# 68060 ERRATA

Rev 4.0 - 10/18/96

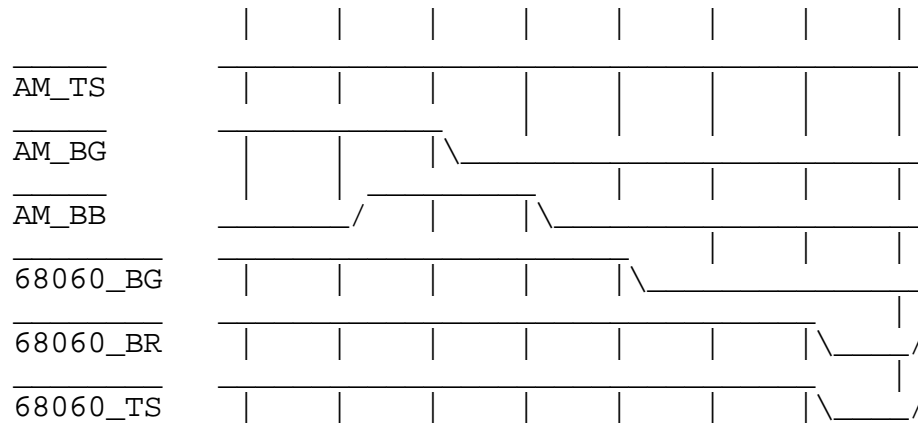
H4 - In systems with at least one alternate master which asserts only BB and not TS during bus tenure the 68060 may incorrectly take over bus mastership. This occurs if BG is asserted to both the alternate master and 060 where the alternate master had, at some time in the past, used the bus, relinquished the bus and started to use the bus again with no intervening bus cycles that assert TS. In this case, the 060 may run bus cycles if an internal request is pending without waiting for the alternate master to finish using the bus and negate BB.

The following timing diagram will illustrate this case.

Have the alternate master assert TS when it starts bus cycles

Assure that the bus grants to an alternate master and 68060 are mutually exclusive

Do not assert BG to the 68060 until the alternate master is done using the bus.
